# Value Engineering Study Report

*Project – STP-012-1(71)), P.I. No. – 621350  
Widening and Relocation of SR 20  
And  
Project – STP-0002-00(626), P.I. No. –0002626  
Interchange Improvements on US 41  
Bartow County*

RE: Submittal of the final Value Engineering Report  
STP-012-1(71) – P.I. No. 621350, SR 20 Widening and Relocation  
STP-0002-00(626) - P.I. No. 0002626, US 41 Interchange Improvements;  
Bartow County  
PBS&J Project Task Order No. 20

**RD-1**

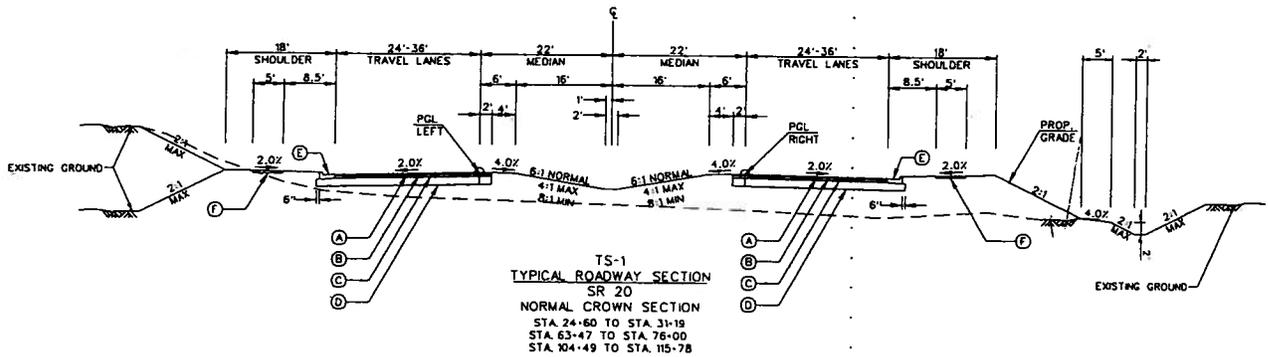
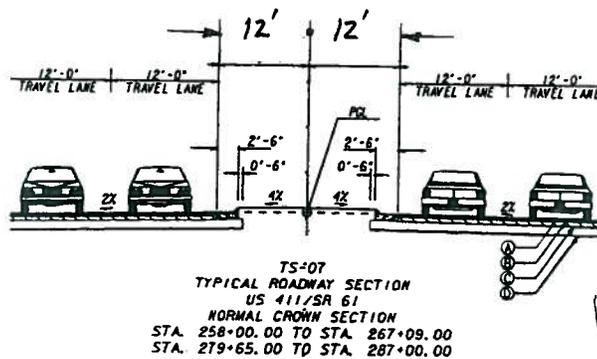
PROJECT:	Georgia Department of Transportation STP-012-1(71) – P.I. No. 621350 SR 20 Widening & Relocation – Bartow County	ALTERNATIVE NO.:	<b>RD-1</b>
DESCRIPTION:	<b>REDUCE MEDIAN WIDTHS TO 24' IN RURAL SECTIONS</b>	SHEET NO.:	1 of 4

ALTERNATIVE NO.: RD-4

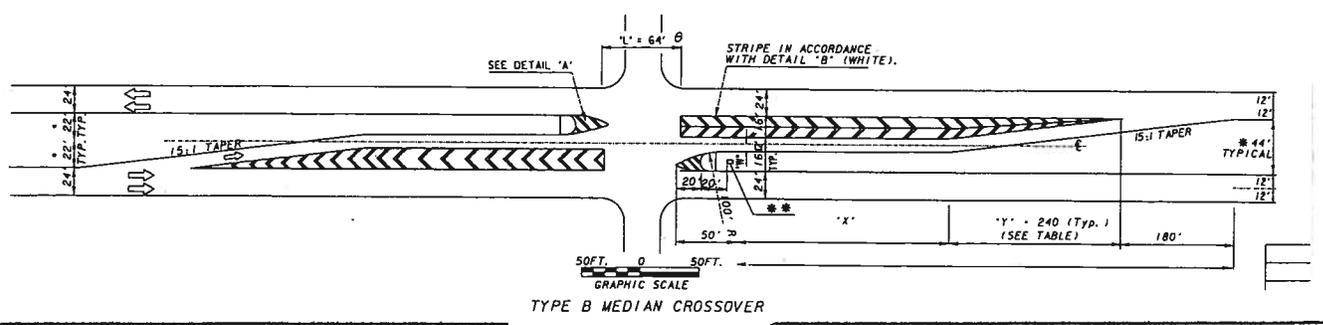
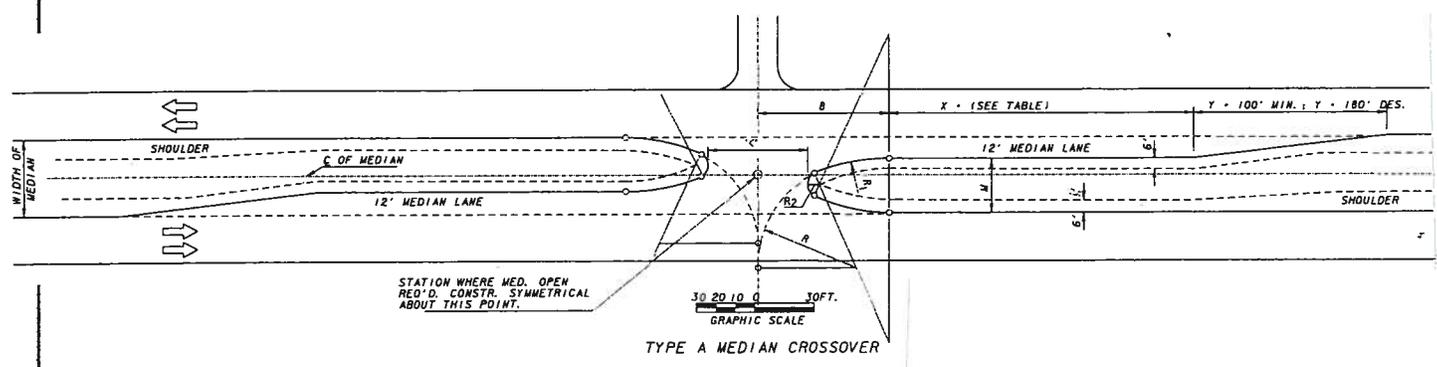
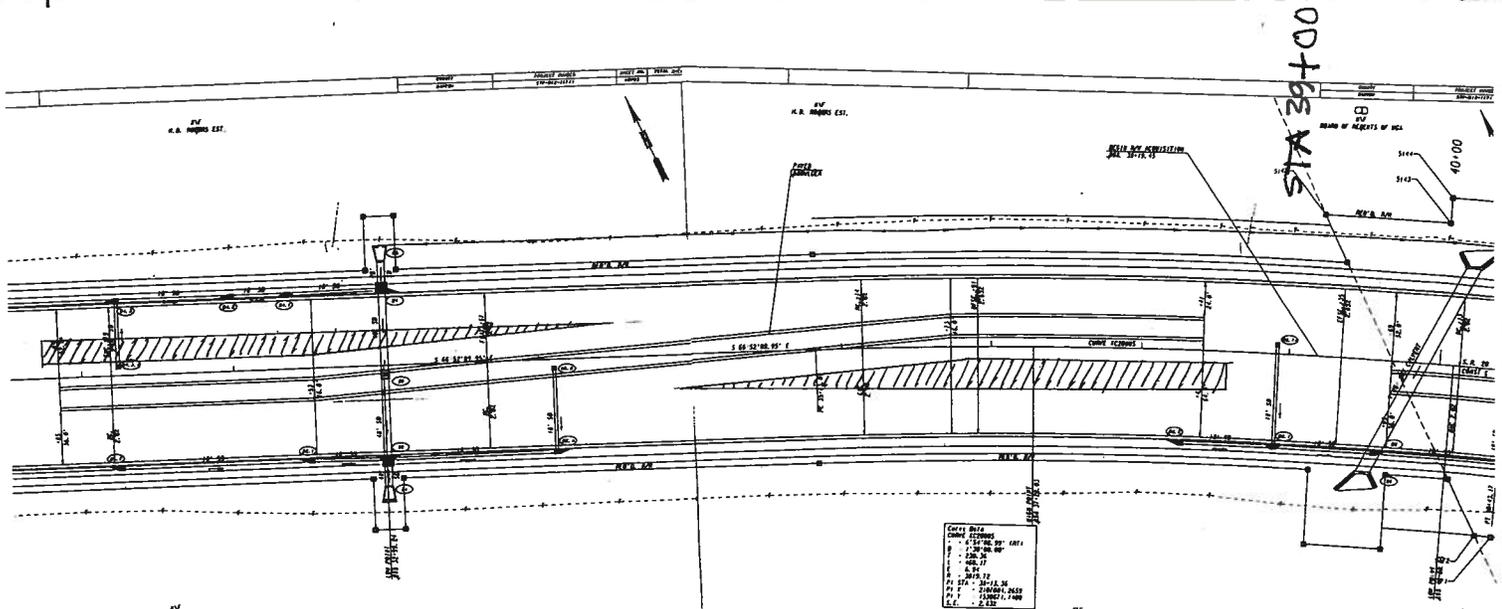
In this rural section we feel that a Type 'A' Crossover would suffice due to the lower traffic volumes which could provide additional savings through the elimination of some paving in these areas.

PROJECT:	Georgia Department of Transportation STP-012-1(71) – P.I. No. 621350 SR 20 Widening & Relocation – Bartow County	ALTERNATIVE NO.:	RD-8
DESCRIPTION:	RELOCATE ONE SIDEWALK TO OTHER SIDE OF THE ROADWAY AND COMBINE WITH A MULTI USE TRAIL	SHEET NO.:	1 of 4

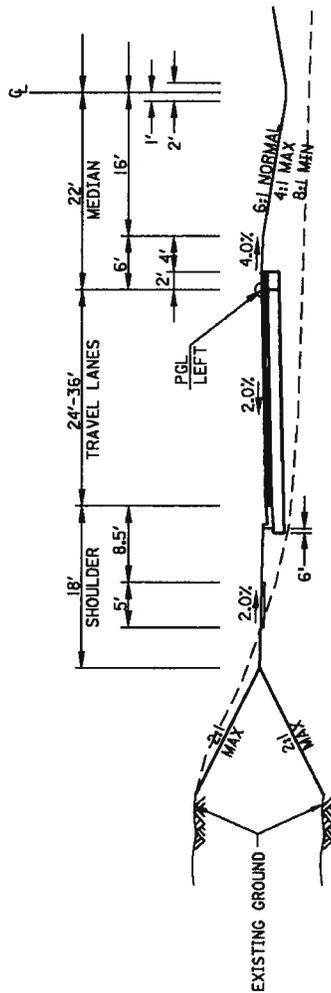
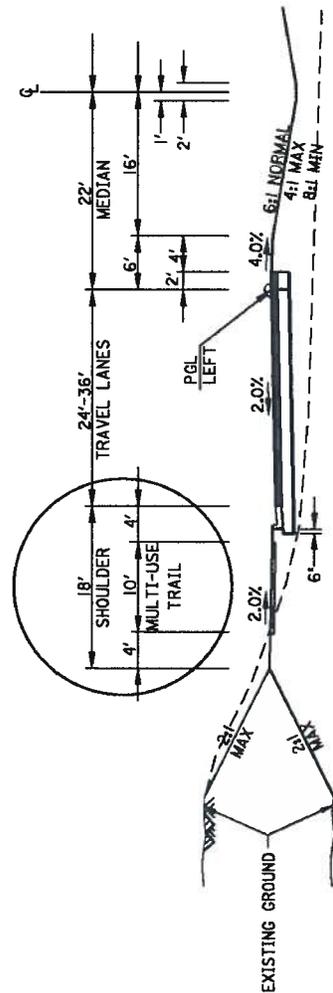
By relocating the pedestrians to one side of the roadway the backbone of the typical section can be reduced.

ALTERNATIVE NO.:  
**RD-13**

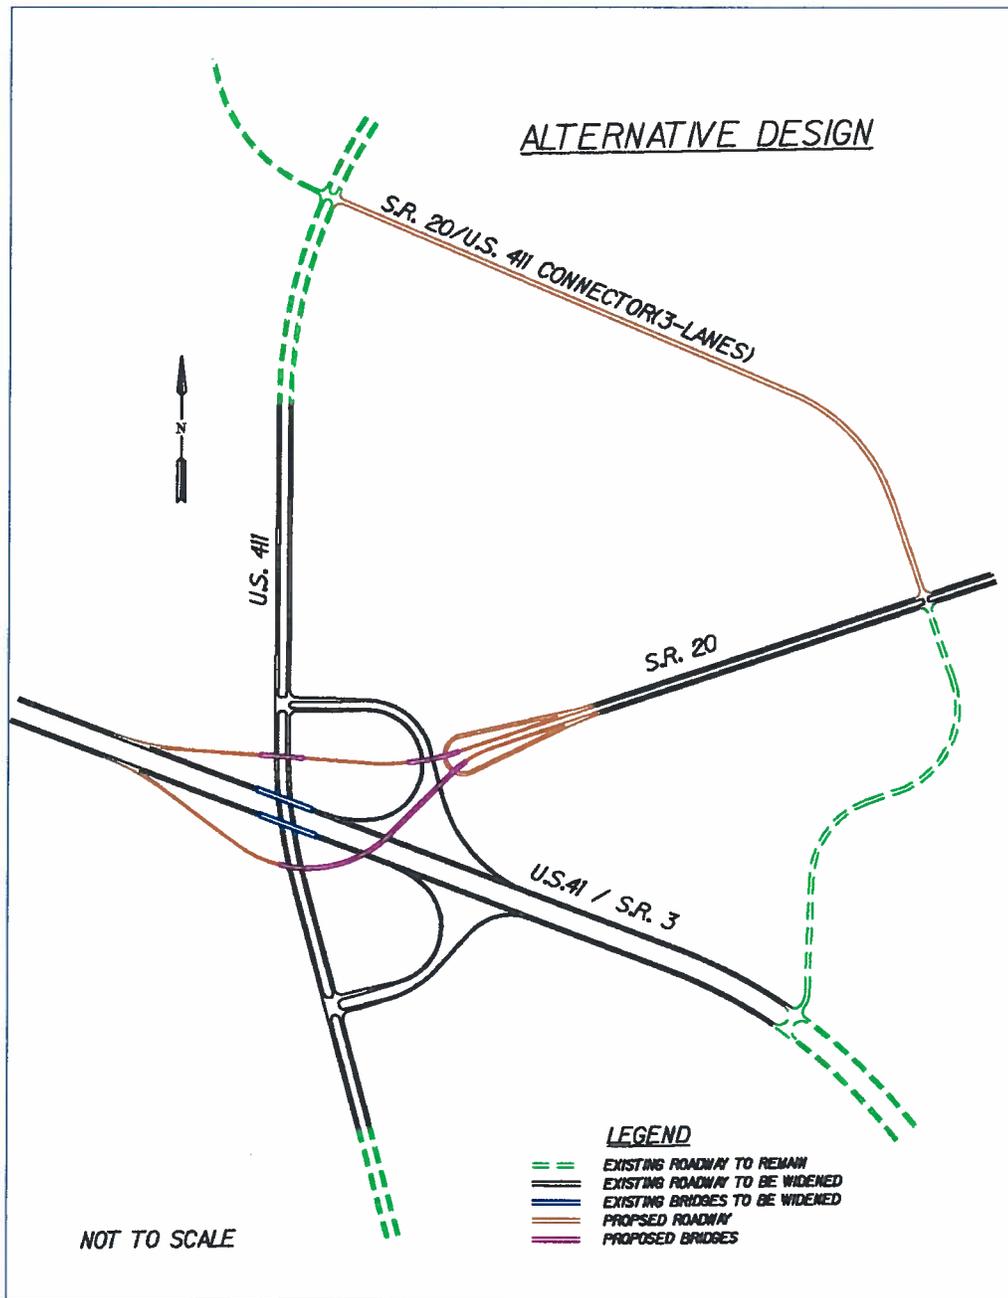
The Original Design proposes building 5-lanes on new location and relocating the SR-20/US-411 intersection approximately 2200' further north of the US-411/US-41 interchange, widening US-411 to 6 lanes from Felton Road to north of "new" SR-20 and reconfiguring the US-411/US-41 interchange to a modified Parclo-B.

The "standard" Parclo-B interchange should be more consistent with driver expectation than the modified version.

PROJECT: <b>Georgia Department of Transportation STP-012-1(71) – P.I. No. 621350 SR 20 Widening &amp; Relocation – Bartow County</b>	ALTERNATIVE NO.:  <b>RD-19</b>
DESCRIPTION: <b>DELETE CURB AND GUTTER</b>	SHEET NO.: 1 of 4

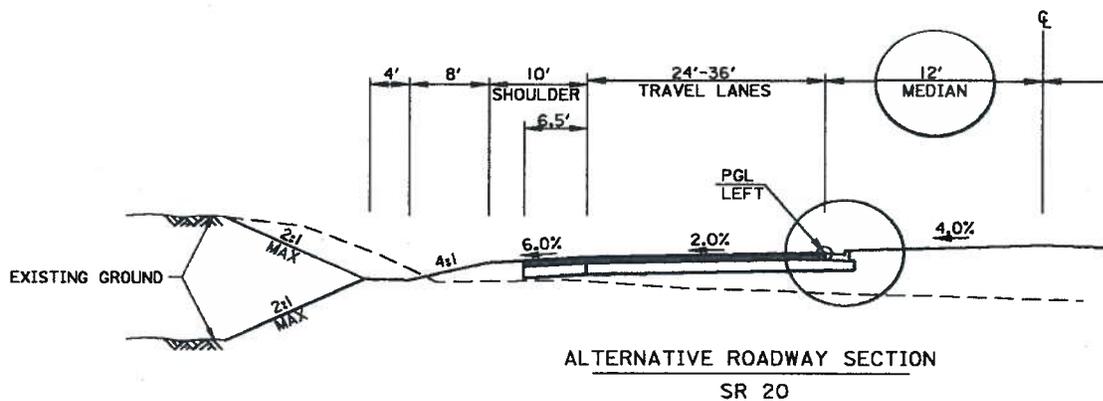
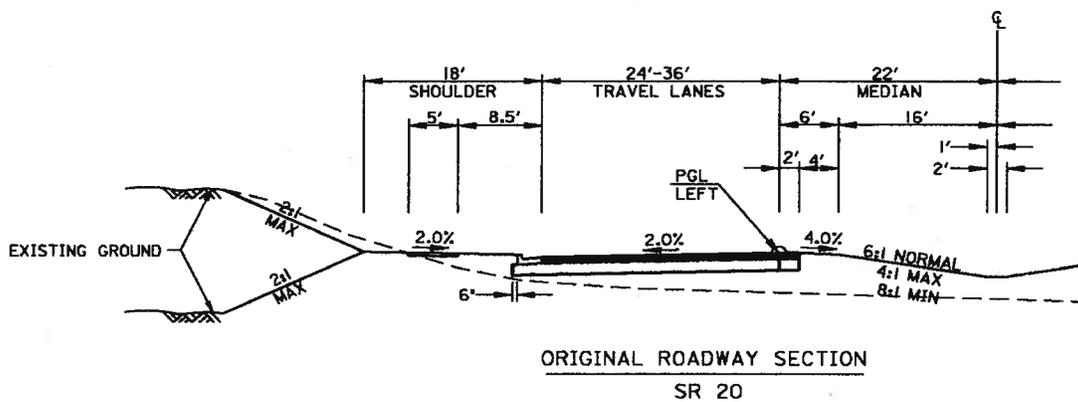
The proposed design is a “hybrid”(rural/urban) section with curb and gutter on the outside and open ditch on the inside. Traditionally this type of section is proposed with curbed median and open ditches on the outside.

**RD20**

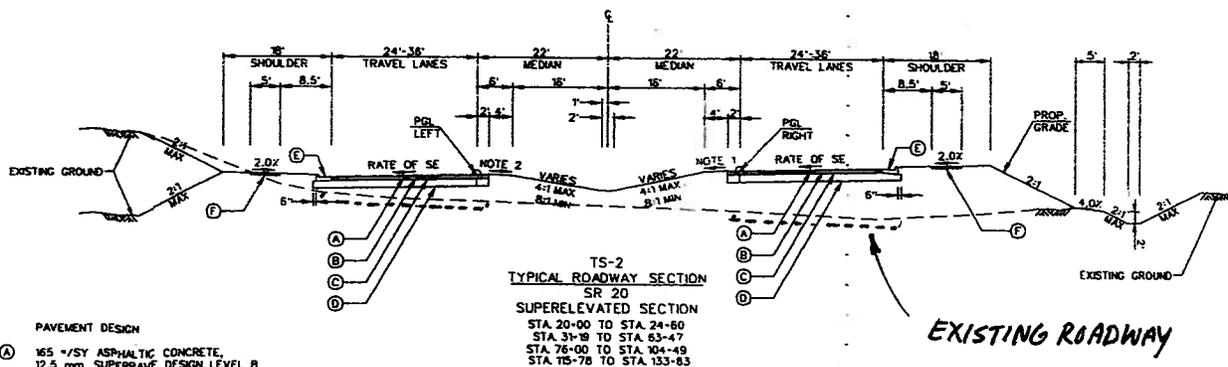
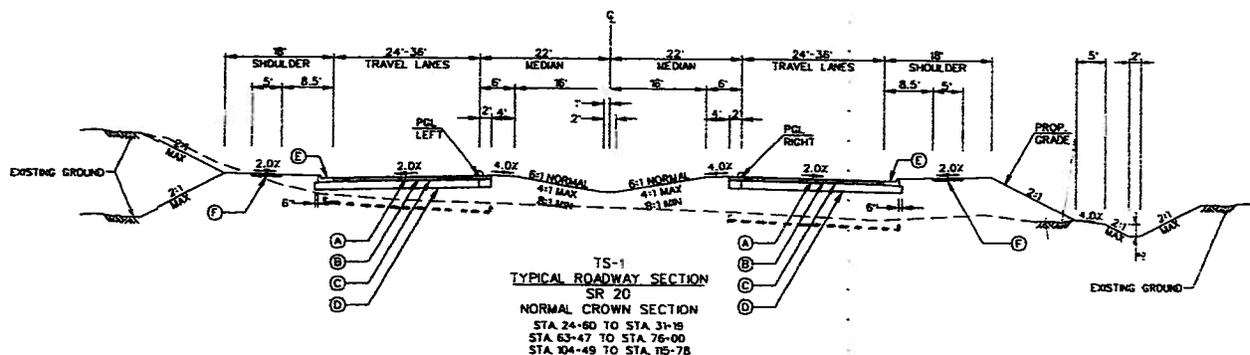
An alternate use for the existing roadway is not addressed in the plans or the estimate. The proposed new profile eliminates the possibility of reusing the existing pavement as part of the new roadway. The existing pavement and base from STA 59+00 to STA 133+83 could therefore be recycled which should result in significant savings.

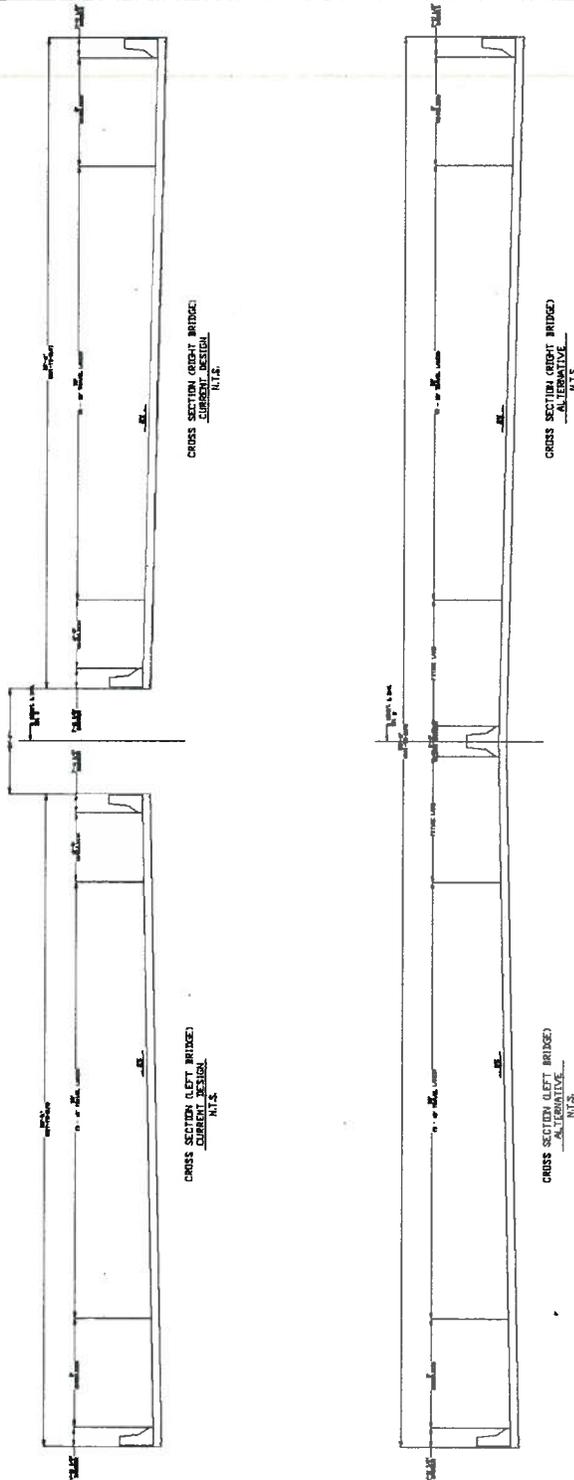
PROJECT:	<b>Georgia Department of Transportation STP-0002-00(626) – P.I. No. 0002626 US 41 Interchange Improvements – Bartow County</b>	ALTERNATIVE NO.:	<b>BRITX-1</b>
DESCRIPTION:	<b>BUILD ONE NEW STRUCTURE (33' WIDER, IN THE MIDDLE) TO FACILITATE CONSTRUCTION IN-LIEU OF USING TEMPORARY BRIDGE</b>	SHEET NO.:	1 of 4

PROJECT:	<b>Georgia Department of Transportation STP-0002-00(626) – P.I. No. 0002626 US41 Interchange Improvements – Bartow County</b>	ALTERNATIVE NO.:	<b>BRRR-2</b>
DESCRIPTION:	<b>REDUCE LENGTH BY ELIMINATING END SPANS AND PROVIDING WALLED ABUTMENTS</b>	SHEET NO.:	1 of 4

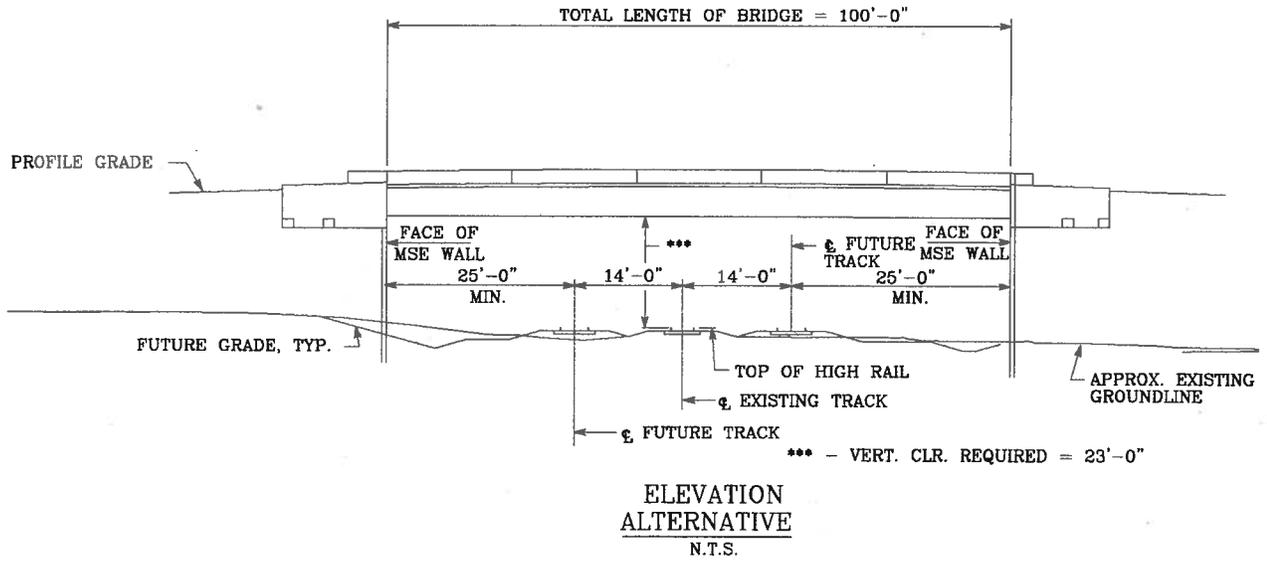
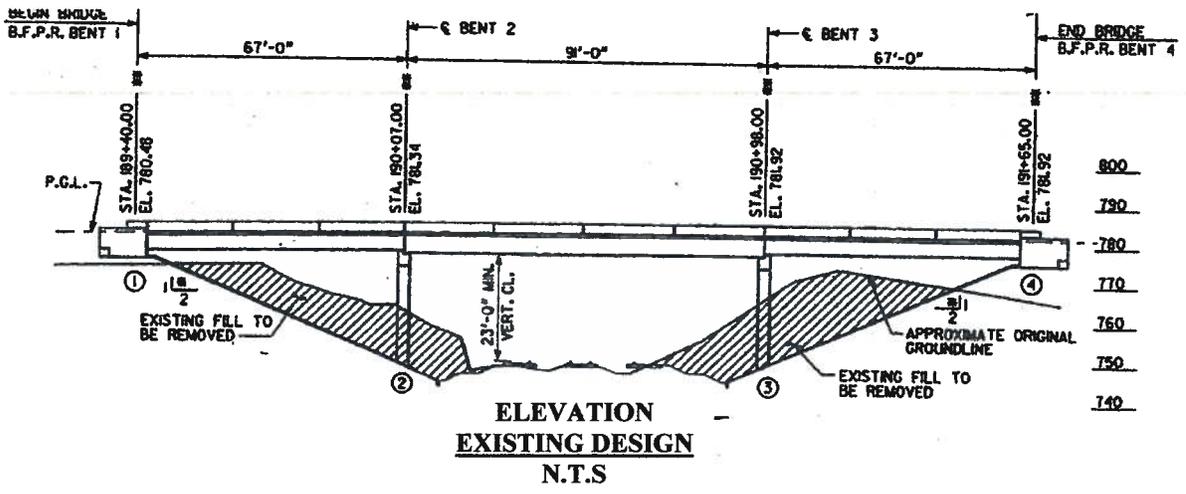
**Note:** Additional cost savings can be realized when the bridge design is developed further and detailed cost estimates are made. The reduction of special barrier rails in the Alternative could be one major component in addition to possible reduction in substructure costs.

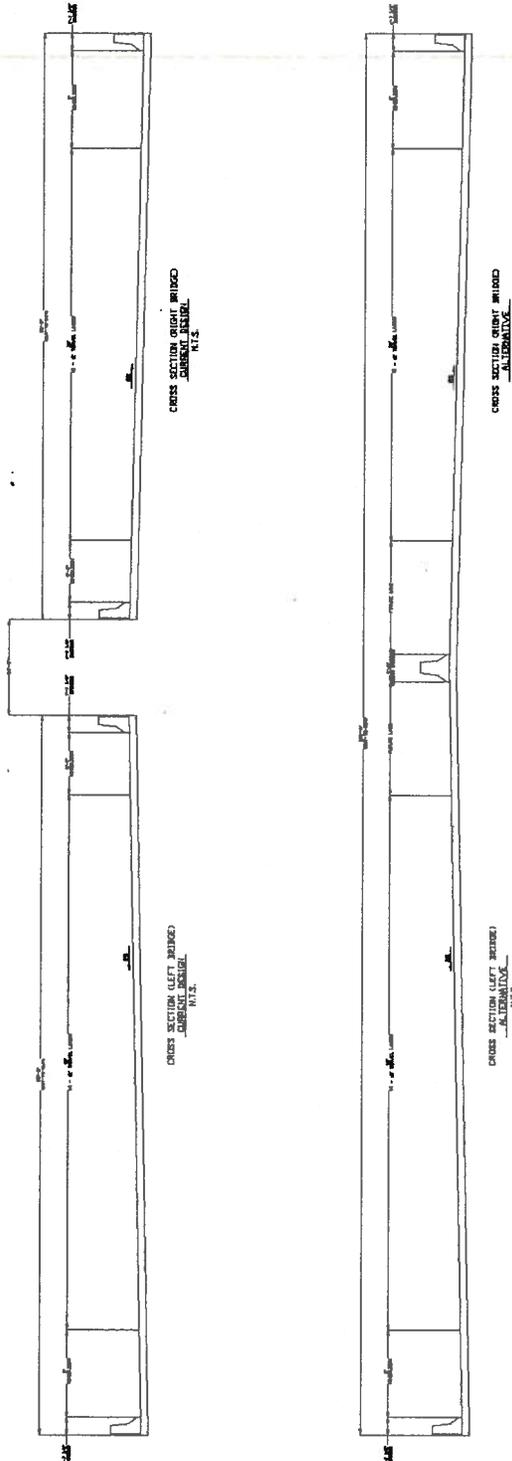
PROJECT:	<b>Georgia Department of Transportation STP-0002-00(626) – P.I. No. 0002626 US41 Interchange Improvements – Bartow County</b>	ALTERNATIVE NO.:	<b>BRRR-4</b>
DESCRIPTION:	<b>BUILD ONE NEW STRUCTURE (21' WIDER, IN THE MIDDLE) TO FACILITATE CONSTRUCTION IN-LIEU OF USING TEMPORARY BRIDGE</b>	SHEET NO.:	1 of 4

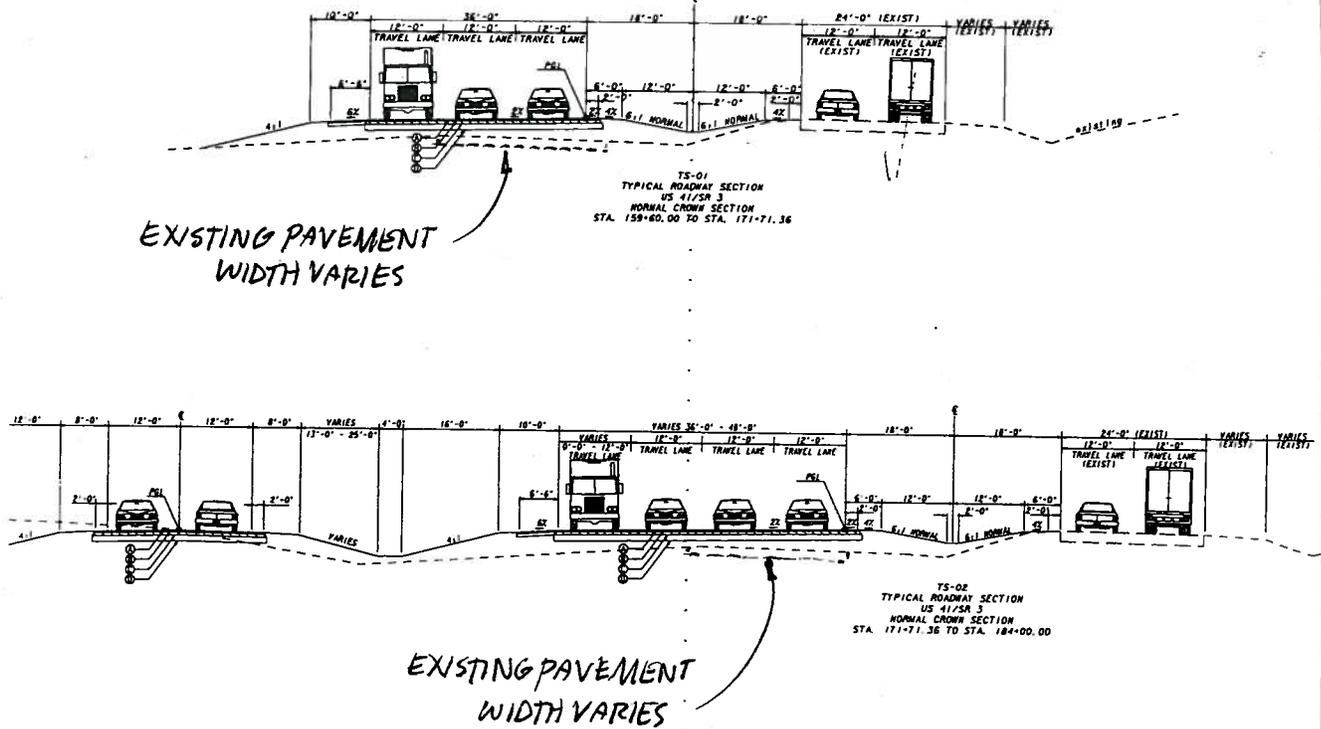
An alternate use for the existing roadway is not addressed in the plans or the estimate. The proposed new profile eliminates the possibility of reusing the existing pavement as part of the new roadway. Various sections of existing pavement and base from STA 159+60 to STA 215+00 could therefore be recycled which should result in significant savings
